*Comment Received From: Joseph Osa
Submitted On: 12/4/2023
Docket Number: 23-OPT-01*

General Scoping Comments and Areas of Concern

Subj: General Scoping Comments and Areas of Concern for the Fountain Wind Project

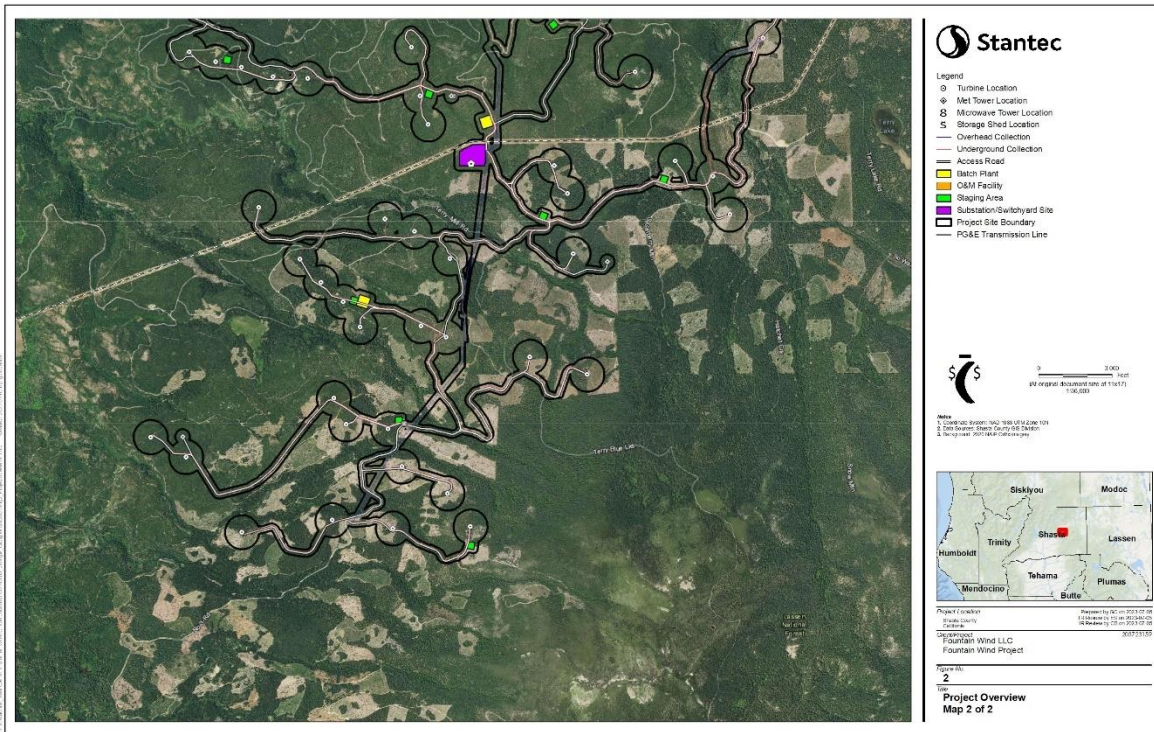
Further effects of turbine wake, in addition to the previously docketed discussion of wake impacts to the power generation of the nearby Hatchet Wind Development, is that of self-interference. It is obvious from the suggested turbine laydown provided by the applicant, as shown below, that there is likely to be multiple cases of self-interference.

Unlike the Hatchet Ridge project where all the turbines are facing the prevailing winds without any of them being downwind of another, the Fountain Wind laydown has many turbines placed such that some are close enough to be impacted by the wake effect with possible further interference in the induction zone forward of the turbines, in the direction of the wind. Ref (B) indicates that wind speeds at turbine hub height can be reduced by 50% or more at 3 turbine rotor diameters (1600 ft) and still reduced by up to 5% at 5 rotor diameters and beyond (2700 ft plus) downwind due to the wake effect and energy extraction and this effect was noted for significantly smaller turbines of only 2.5 MW. Even upwind, in the induction zone, there is significant wind speed reduction up to 3 rotor diameters (1600 ft) away although without much of the turbulence seen downwind in the wake. Any reduction in windspeed will cause a significant reduction in power output because of the power curve and the cubic relationship

The co-interference effect should be modeled for all proposed configurations to determine a more accurate capacity factor so that the overall efficiency of this

North Valley Area – Results (cont'd)

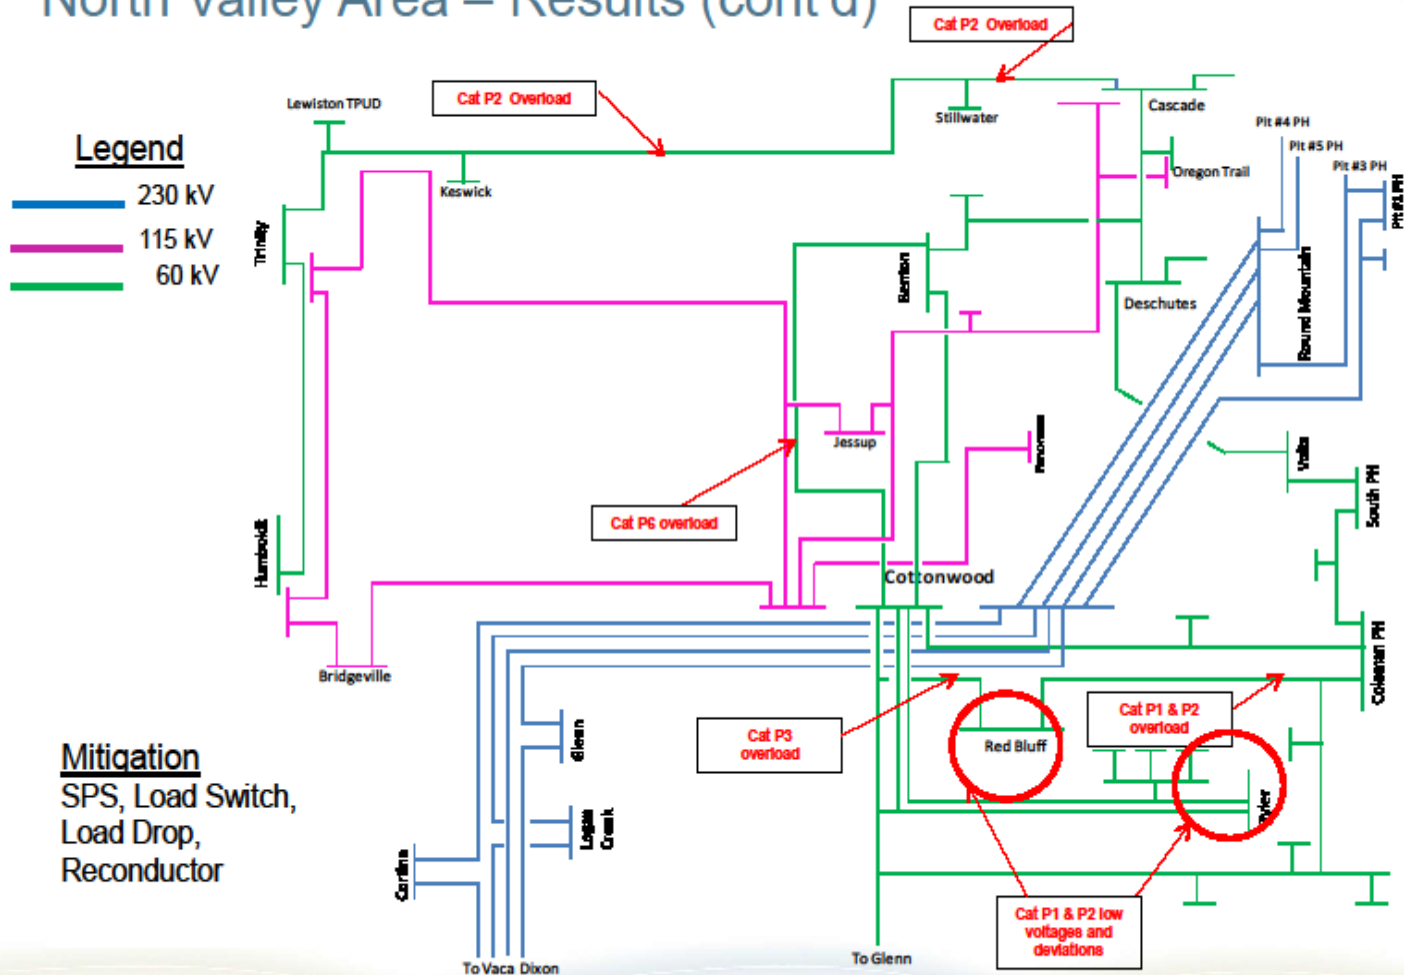
The more recent 2020-2021 Transmission Plan has also identified reliability issues and needed upgrades required to the Cottonwood/Round Mountain 230kV bus as follows:

...Cottonwood 230 kV bus overloads the underlying 115 kV and 60 kV network connected to the Cottonwood substation under the peak load scenario in the near term.

...Round Mountain 230 kV bus overloads the Round Mountain – Cottonwood 230 kV Line under the peak load scenario in the near term.

The CAISO is recommending protection upgrades at Cottonwood 230 kV and Round Mountain 230 kV substations to address overload under P5-5 contingency.
